# Access Compliance Report

## Public Rights-of-Way

### (Pedestrian Signals)

Intersection ID: N/A	Main Street:	Cross Street: N/A	Location: N/A
ADA ID: E923A877C30C	Signal Type: One Push Button-Non APS	Overall Compliance: No	Severity Score: BTN 1: N/A BTN 2: N/A No BTN: N/A
Codes/Mitigation Info/Possible Solution		Field Measurements/Component Compliance

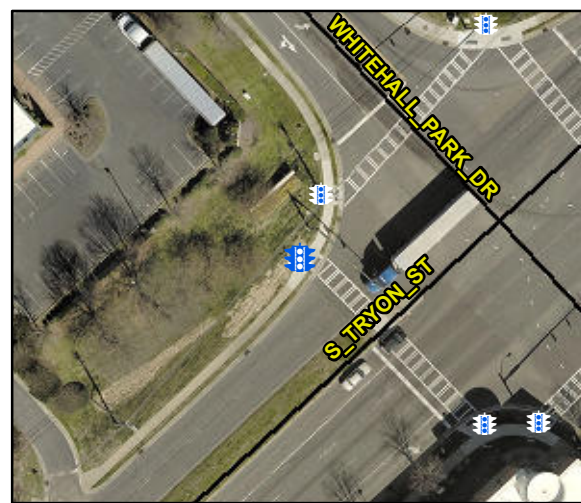
Surveyor Notes: TEXT HT 1/2. LANDING CURB 7.0 WIDE BETWEEN POST & CLEAR SPACE

PROW/ADA: R410.6, R209.1, TMUTCD 4e.08, R404.2, R404.7.3

Possible Solutions: Replace Signal Push Button With APS Button on New Post. Remove & Replace Sign.
